# STATE OF VERMONT AGENCY OF TRANSPORTATION

## PROPOSED IMPROVEMENT TOWN OF RUTLAND COUNTY OF RUTLAND US ROUTE 7 (PRINCIPAL ARTERIAL) (NHS)

REPLACEMENT AND UPGRADE OF TRAFFIC SIGNAL EQUIPMENT TO INCLUDE NEW MAST ARMS  
AND MAST ARM POLES, NEW VEHICLE DETECTION, NEW PEDESTRIAN EQUIPMENT, A NEW SIGNAL  
CONTROLLER AND OTHER HIGHWAY RELATED ITEMS.

SUBJECT: RUTLAND TOWN NHG 019-3(60) SHOP DRAWING APPROVAL

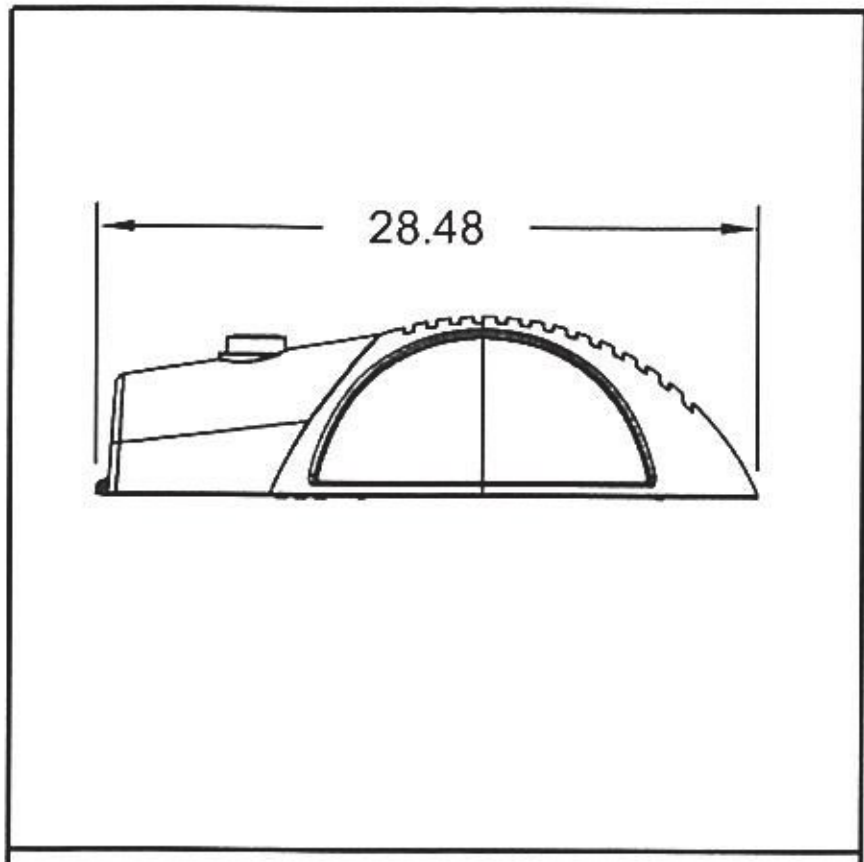
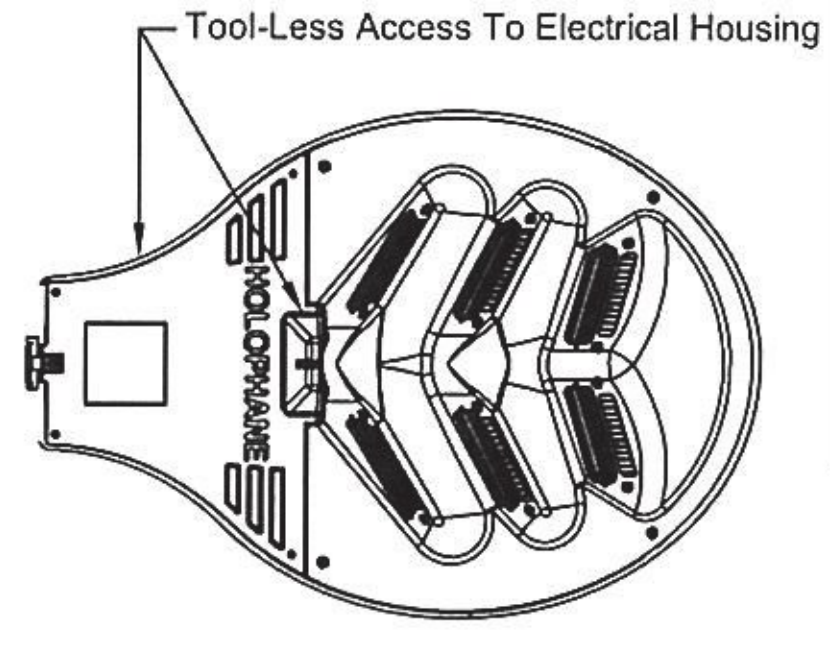
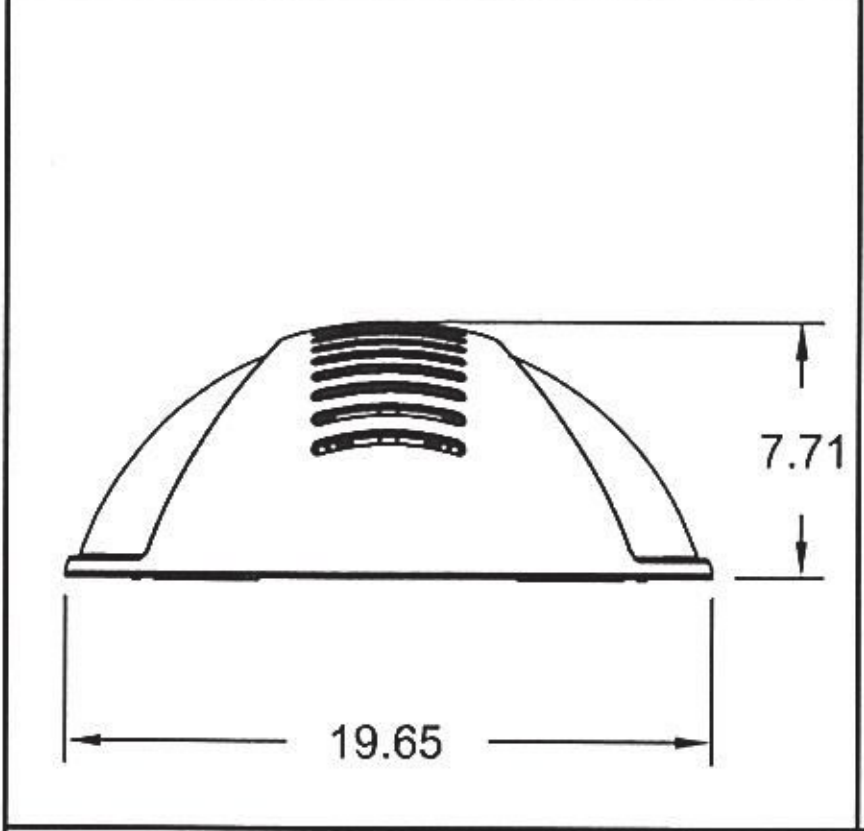
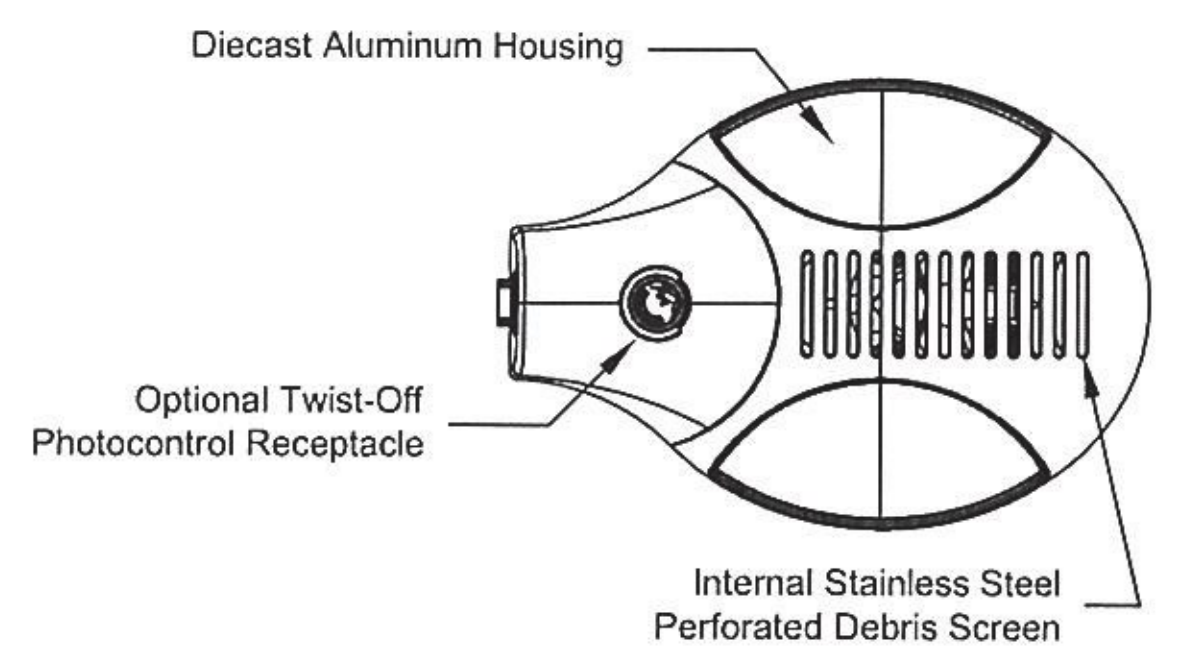
- Holophane LEDGENE Series
  - Shall be housing color code "K = Black"
- Bird-X Bird Spikes
  - Shall be the "Stainless SPIKES Needle Strips," regular sized product only

Job Name: RUTLAND NHG019-3(60)  
 Customer: LAFARO ELECTRIC  
 Base #: PO #1, PO #2, PO #3  
 Quantity: 3  
 Conduit Size: 2" + 1/2"  
 Bolt Pattern Ø: 14"

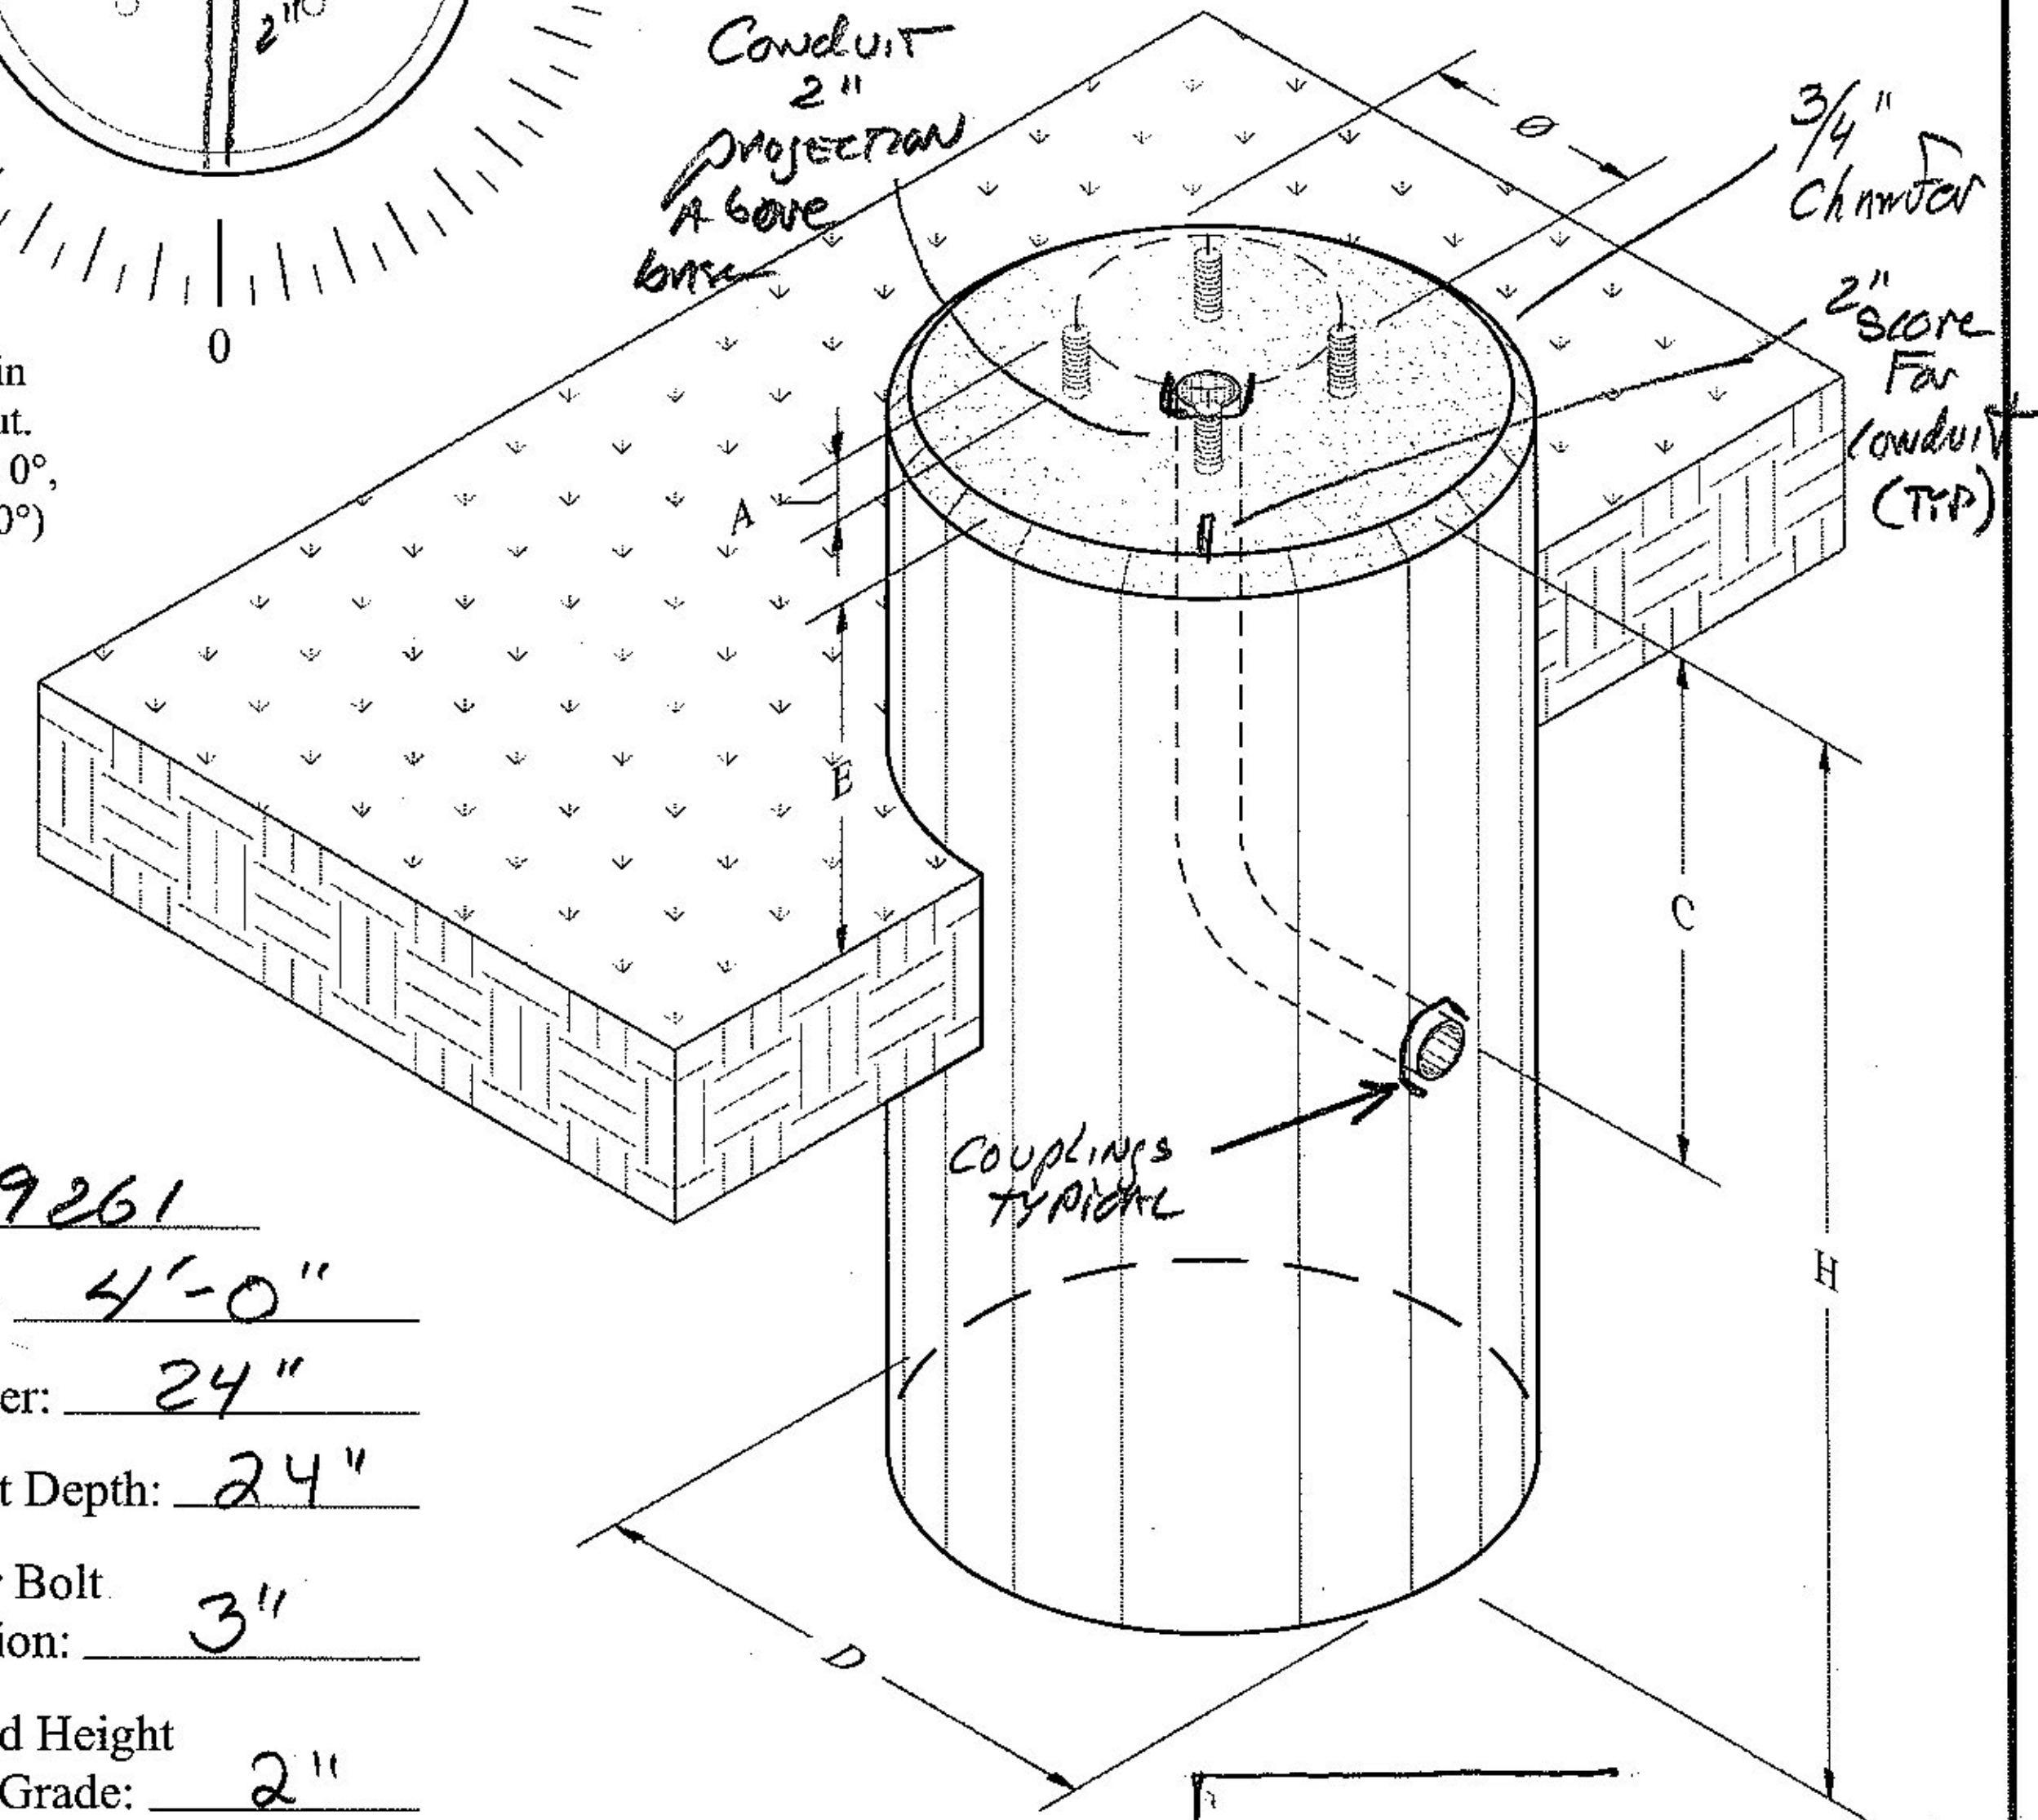
Please Draw in  
 Conduit layout.  
 (Suggested at 0°,  
 90°, 180°, 270°)

**17" x 30" PG Style (Stackable) Assembly  
and 17" x 30" PD Style Assembly**

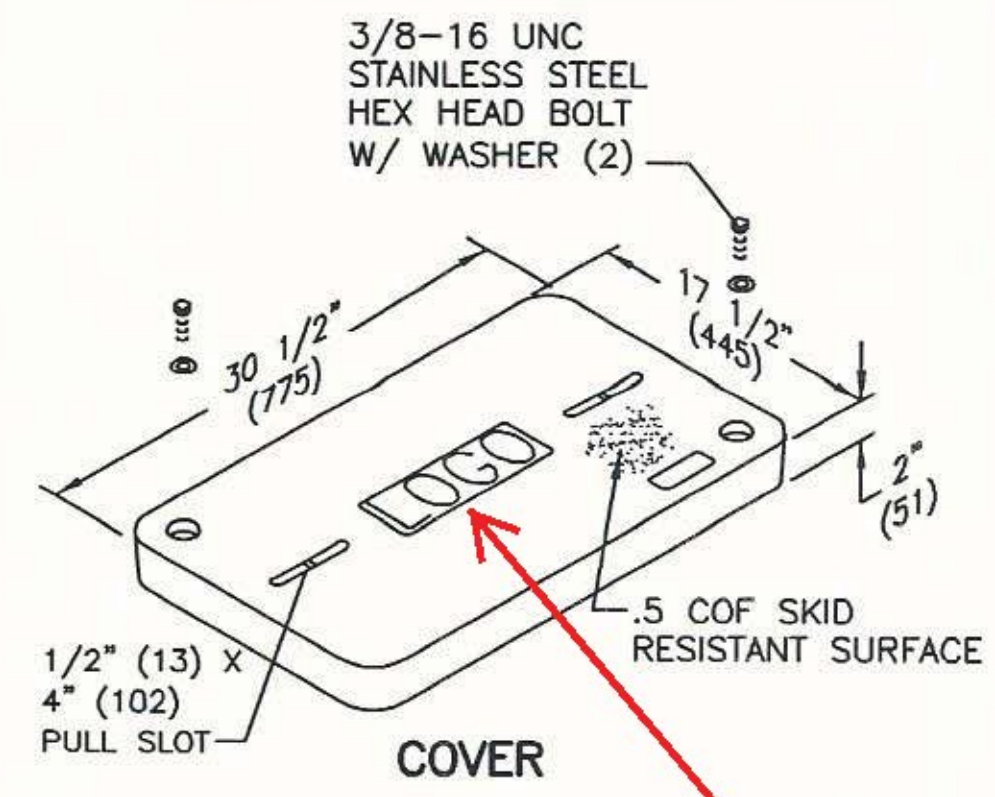
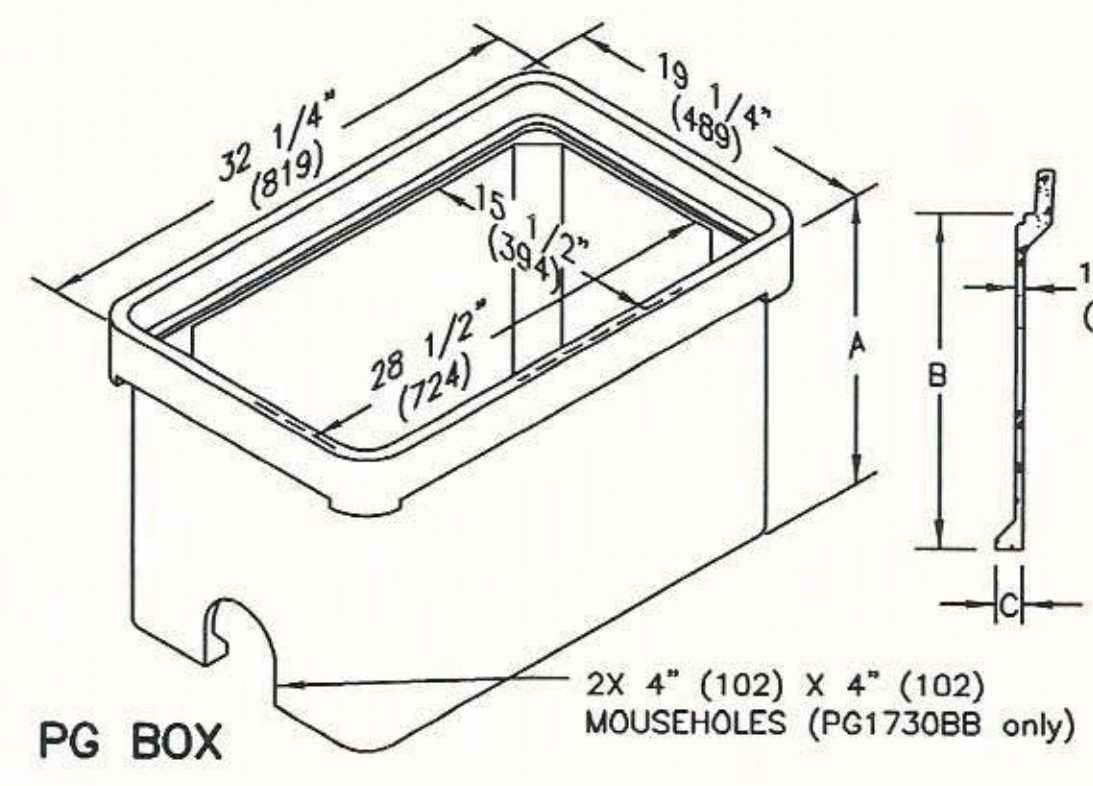
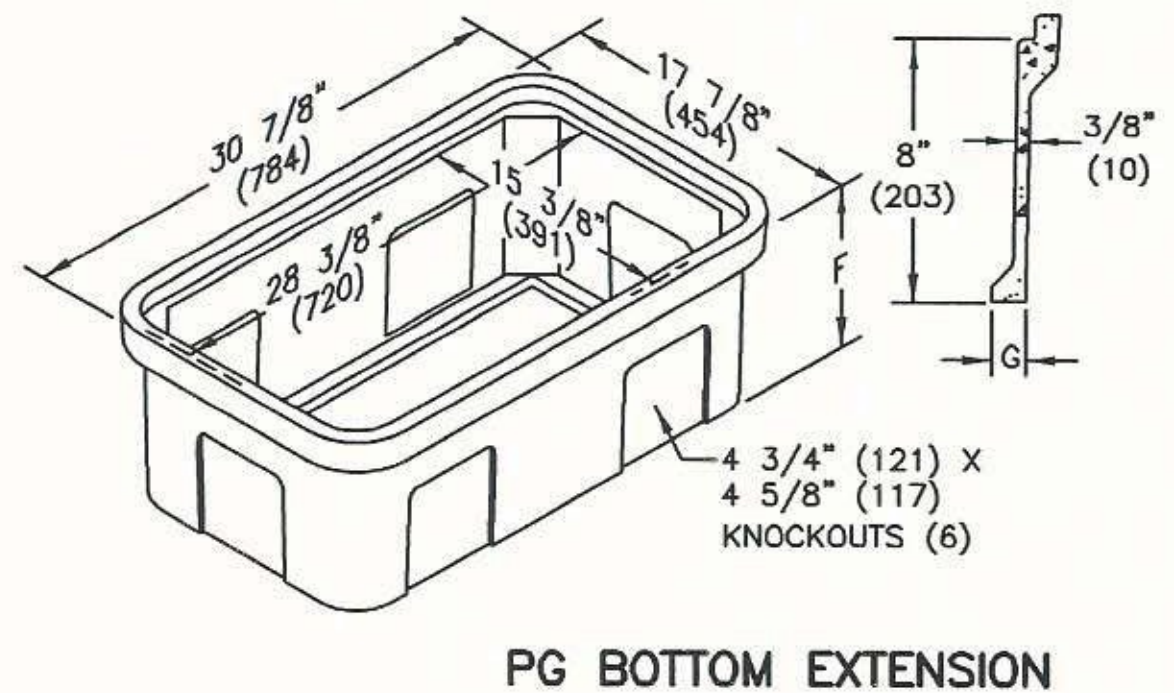
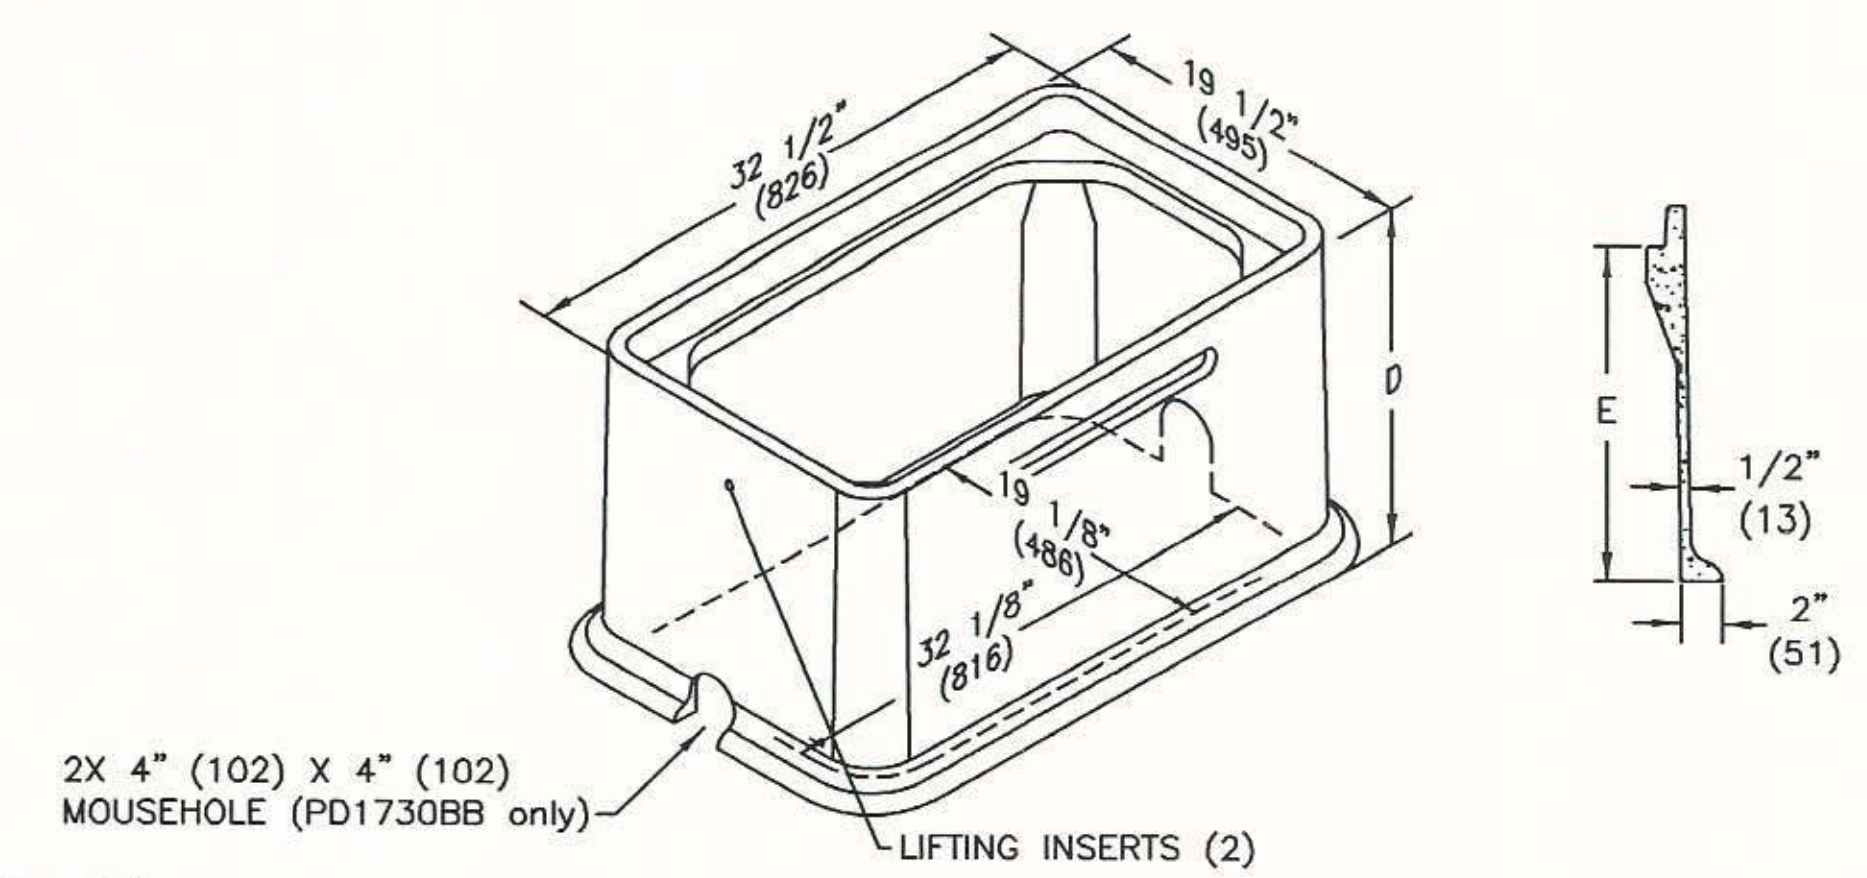
The following equipment has been **approved as noted** in the attached shop drawing response document:
